Subject: Sand Island Parkway Wastewater Pump Station Modifications, TMK 1-5-41:5, Honolulu, Oahu, Hawaii; Final Environmental Assessment (EA) and Finding of No Significant Impact (FONSI)

SAND ISLAND PARKWAY
WASTEWATER PUMP STATION MODIFICATIONS
HONOLULU, OAHU, HAWAII

FINAL ENVIRONMENTAL ASSESSMENT

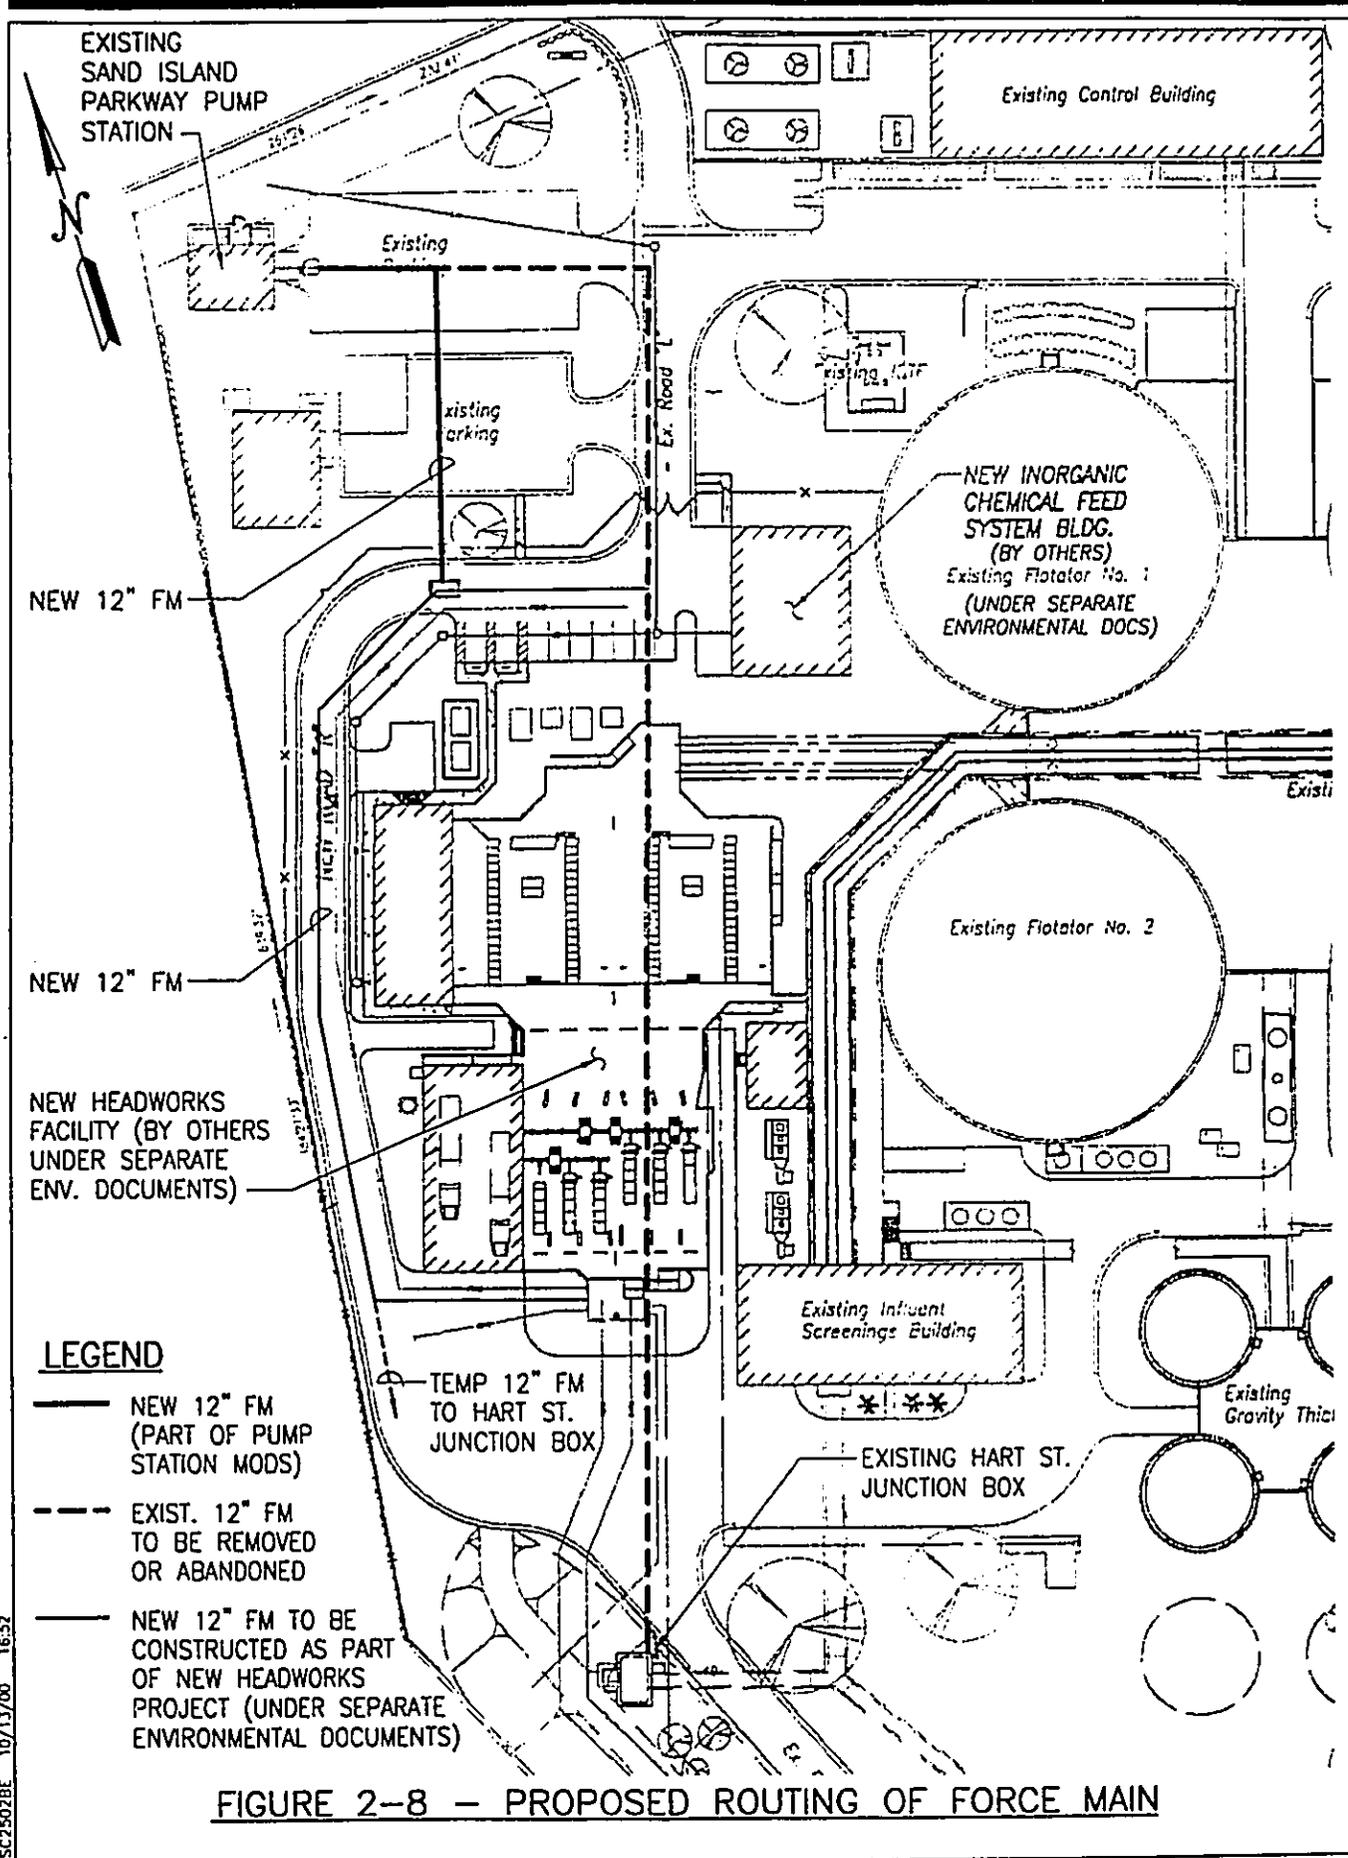
6. **COMMENT:** "The DEA should include the entire alignment of the force main in a site plan of the project."

RESPONSE: *A figure showing the proposed routing of the replacement force main will be included in the Final EA. A copy of this figure is attached for your information.*
